UNITED STATES PATENT AND TRADEMARK OFFICE

10/583,303

Office Action Summary	Application No. 10/583,303	Applicant(s) RITTER ET AL.	
	Examiner STEPHANIE JENNINGS	Art Unit 4135

DETAILED ACTION

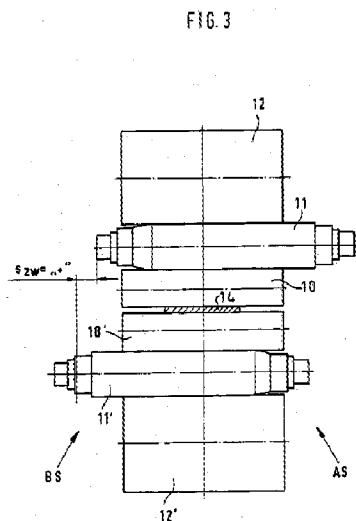
Limitations from claim 5, tandem cold rolling mill, comprising four-high/six-high rolling mills, each with a pair of work rolls (10, 10', figure 3) and a pair of backup rolls (12, 12', figure 3) in the case of four-high rolling stands and, in addition, a pair of intermediate rolls (11, 11', figure 3) in the case of six-high rolling stands, wherein at least the work rolls (10, 10', figure 3) and the intermediate rolls (11, 11', figure 3) interact with axial shifting devices (figure 4), wherein the work rolls/intermediate rolls (10, 11, figure 3) of the rolling stands each have a symmetrical barrel (10, 11, figure 3) which is lengthened by the amount of the shifting stroke, has a cylindrical or cambered cross section, and is symmetrically positioned in the center of the stand (Y-Y) for the neutral shift position ($S_{ZW} = "+"$, figure 3), page 2, ¶ 32-39.

FIG. 2

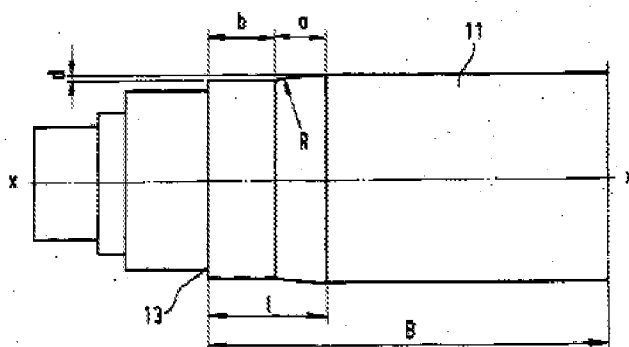
Limitations from claim 6, tandem cold rolling mill in accordance with claim 5 in figure 2 (above), wherein the barrel of the work rolls/intermediate rolls (10, 11) is furnished with a one-

sided setback (d), whose length (B) is divided into two adjacent regions (a) and (b), such that the first region (a), beginning with the radius (R), obeys the equation of the circle $(B-X)^2 + y^2 = R^2$, and the region (b) runs linearly, from which the following setback (d) or the following diameter reduction (2d) is obtained for these regions:

FIG. 3

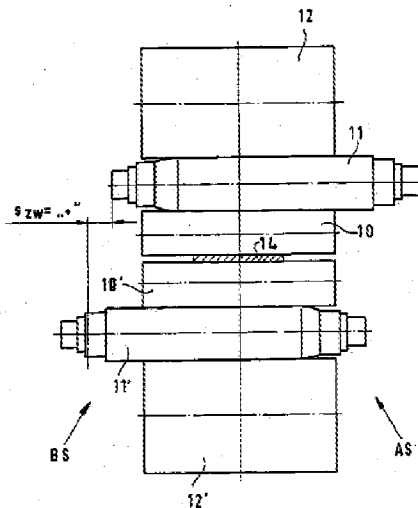
Limitations from claim 1, Method for the operation of the rolling stands of a tandem cold rolling mill, comprising a pair of work rolls (10, 10', figure 3) and a pair of backup rolls (12, 12', figure 3) in the case of four-high rolling stands and, in addition, a pair of intermediate rolls (11, 11', figure 3) in the case of six-high rolling stands, wherein at least the work rolls (10, 10', figure 3) and the intermediate rolls (11, 11', figure 3) interact with axial shifting devices (figure 4, wherein m="+" or m="-" indicates shifting), comprising the combined use of the following technologies within the multiple-stand tandem cold rolling mill: use of CVC/CVC^{plus} technology

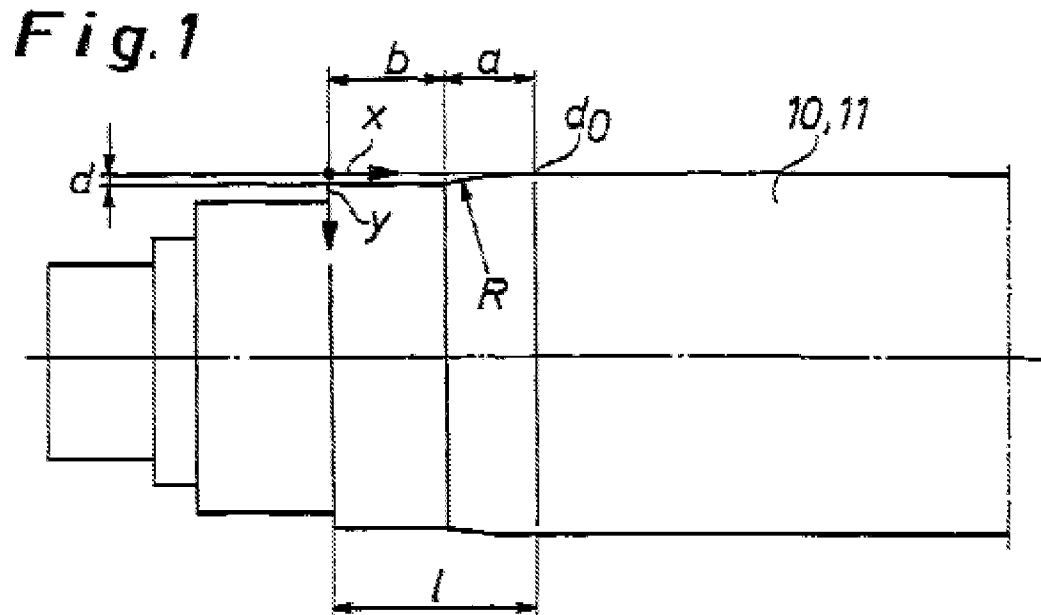
wherein each work roll/intermediate roll (10, 10', 11, 11', figure 3) has a barrel lengthened by the amount of the shifting stroke, wherein each work roll/intermediate roll (10, 10', 11, 11', figure 3) has a barrel (10, 11) which is lengthened by the amount of the shifting stroke and which has a cylindrical or cambered cross section, and the work rolls/intermediate rolls (10, 10', 11, 11', figure 3) are each symmetrically shifted from the neutral shift position ($S_{ZW} = "+"$, figure 3) by the same amount symmetrically to the center of the stand (Y-Y) in the direction of their axes of rotation (X-X) (page 1, ¶ 1, 3-7).

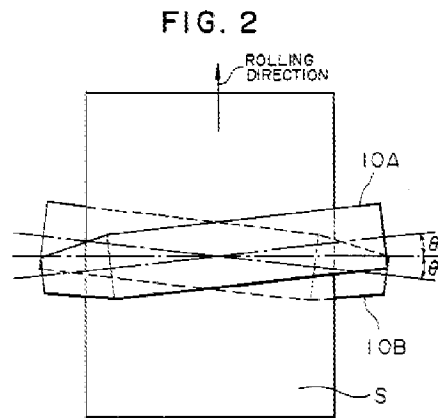
Limitations from claim 8, Tandem cold rolling mill in accordance with claim 5, wherein suitable choice of the rolling stands allows a combination of the different technologies of strip edge-oriented shifting of the work rolls/intermediate rolls (10, 11). CVC technology (page 1, ¶ 3-7), and swiveling of the work rolls (10), PC (pair cross) technology within the multiple-stand tandem cold rolling mill.

Limitations from claim 8, Tandem cold rolling mill in accordance with claim 5, wherein suitable choice of the rolling stands allows a combination of the different technologies of strip edge-oriented shifting of the work rolls/intermediate rolls: CVC technology, and swiveling of the work rolls, PC (pair cross) technology (10A, 10B in figure 2 above and column 4, lines 19-33) within the multiple-stand tandem cold rolling mill.
